Subject: MHI's Responses to the Questions at ACRS Subcommittee Meeting on May 21, 2009

MHI's Responses to the Questions at ACRS Subcommittee Meeting
regarding Qualification and Test Plan of
Class 1E Gas Turbine Generator System

REPORT NO.: MUAP-07024
REPORT TITLE: QUALIFICATION AND TEST PLAN OF CLASS 1E GAS
TURBINE GENERATOR SYSTEM
DATE OF MEETING: 5/21/2009

Figure-1

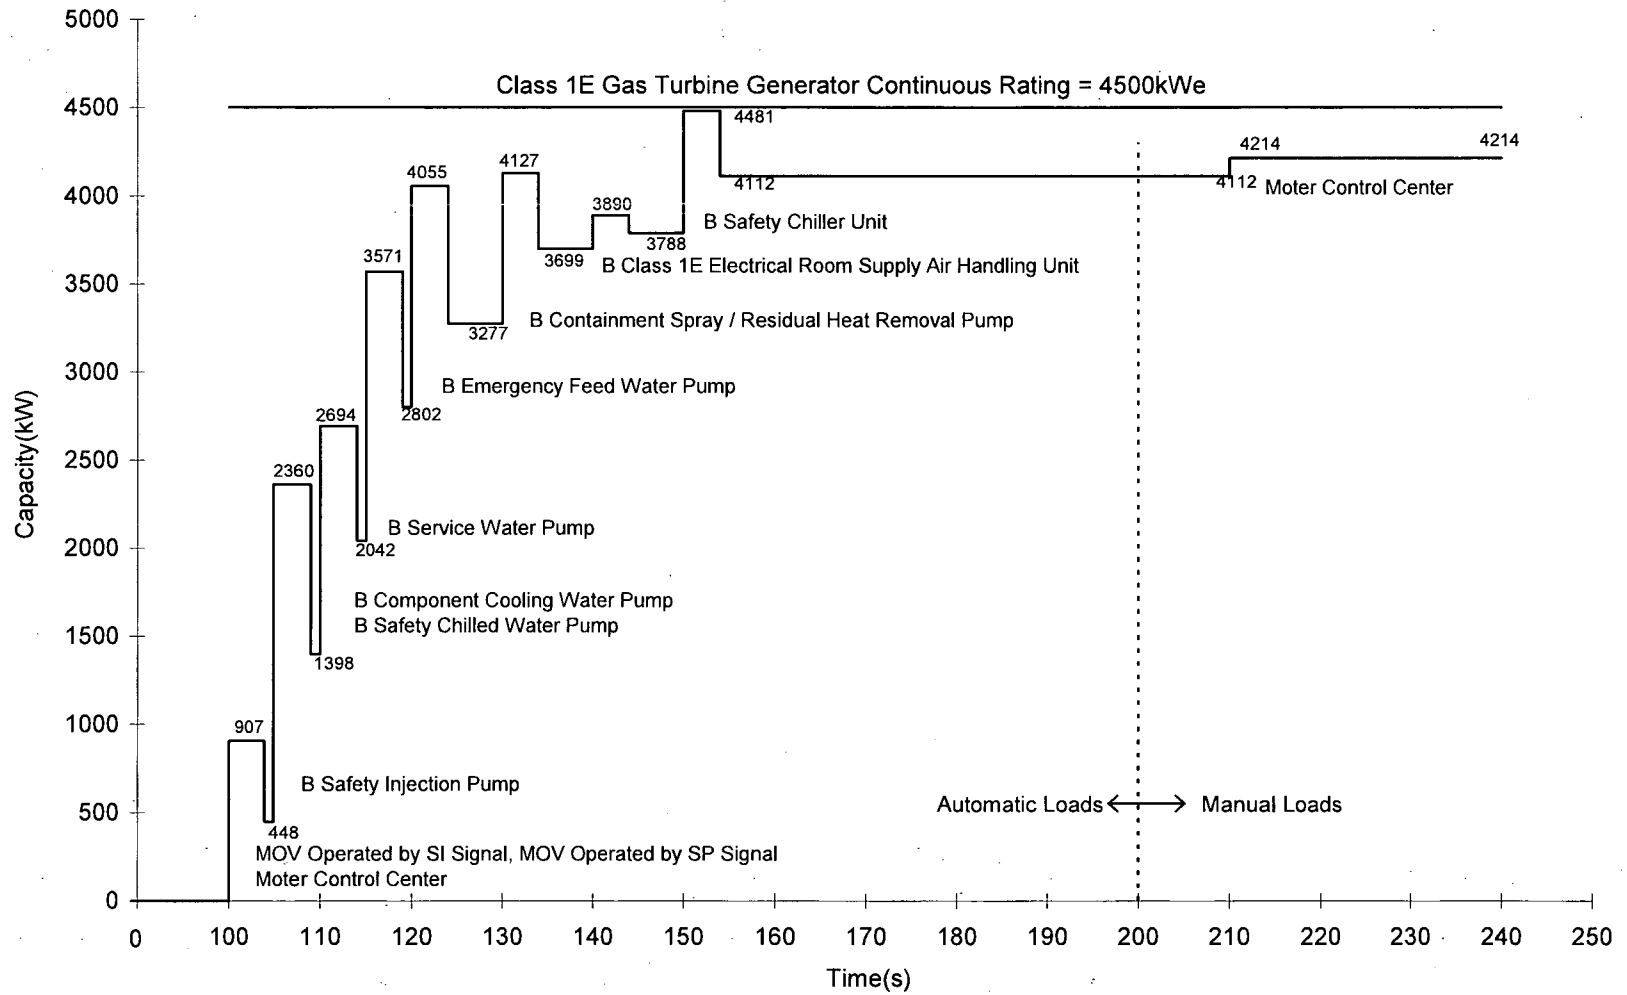
MHI is requested to clarify to the sheet-16.

Figure of sheet 16 of presentation document explained by MHI on meeting was not correct. Figure-1 is correct figure. "Zero (0)" of Figure-1 means timing when starting signal is initiated. The Class 1E GTG is started by starting signal. It reaches the rated voltage and frequency, and breaker is closed within 100 seconds. After that, each load is started in accordance with sequence logic.
